**PLANNING DEPARTMENT
CURRENT PLANNING STAFF ANALYSIS
PLATTING**

DATE: May 19, 2021

CASE: S12607
Palaterra Subdivision, Lots 1-6 and Tract A

Subdivision of two (2) lots into twelve (12) lots with a variance from AMC 21.08.030.F.5 *Street Intersections*- requiring the distance between intersection centerlines to be at least 150 feet.

Lots 1-12,
Palaterra Subdivision
Addition 2

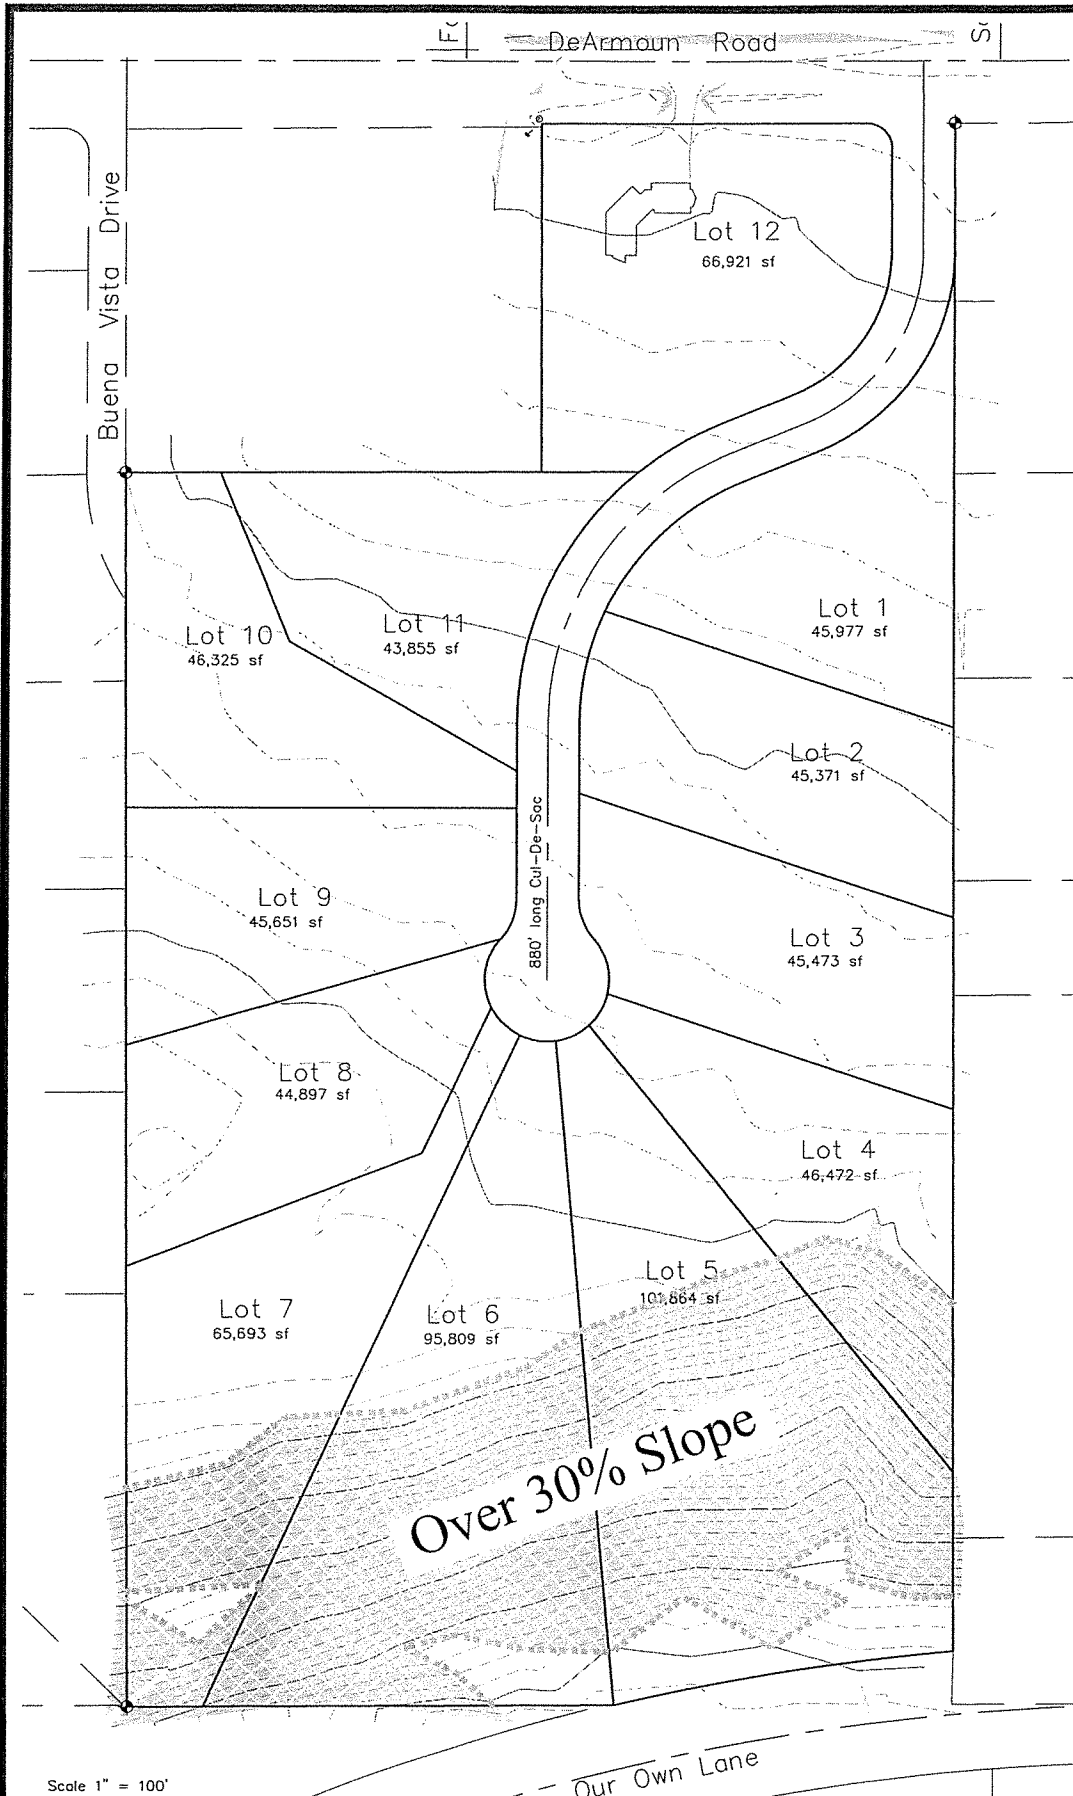
- a. Construct the unnamed internal road as a 20-foot wide strip paved road in accordance with MASS detail 20-1 and AMC Table 21.08-4 as required for the Class B improvement area per AMC 21.08.050. The cul-de-sac shall be constructed with a 39.5-foot radius.

4. Submit to Private Development for review and approval a comprehensive site grading and drainage plan to resolve the need for drainage easements and drainage improvements and to demonstrate that all post development drainage patterns will not adversely impact adjacent properties or rights of way, and to include a suitable outfall. Required drainage improvements and runoff quantities shall be designed in accordance with the Municipality of Anchorage Design Criteria Manual Chapter 2.

- a. In the platted area:
 - i. Provide 30-foot radius intersections for Lots 1 and 12 per DCM 1.9F.
